CITY OF BLAINE

STAFF REPORT and RECOMMENDATION TO PLANNING COMMISSION Type II Quasi-Judicial Decision – Conditional Use Permit

Site Location: 150 8th Street, Blaine WA

Application: Conditional Use Permit

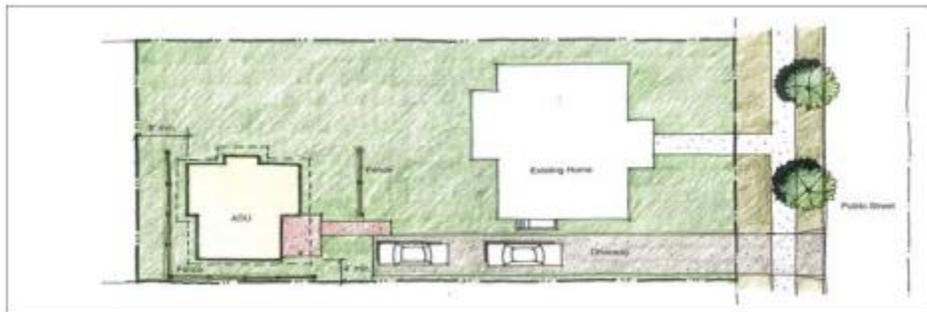
Discussion: *As an accessory structure, the garage, which was constructed in 2013, would have been required to comply with the rear yard setback of 8 feet, and a side yard setback of 4 feet (BMC 17.34.040 and BMC 17.104). An 8-foot setback is depicted on the site plan (Attachment B.2), and a 7’6” setback along the north side yard. As a result, the garage is compliant with accessory structure setbacks and this standard is not applicable.*
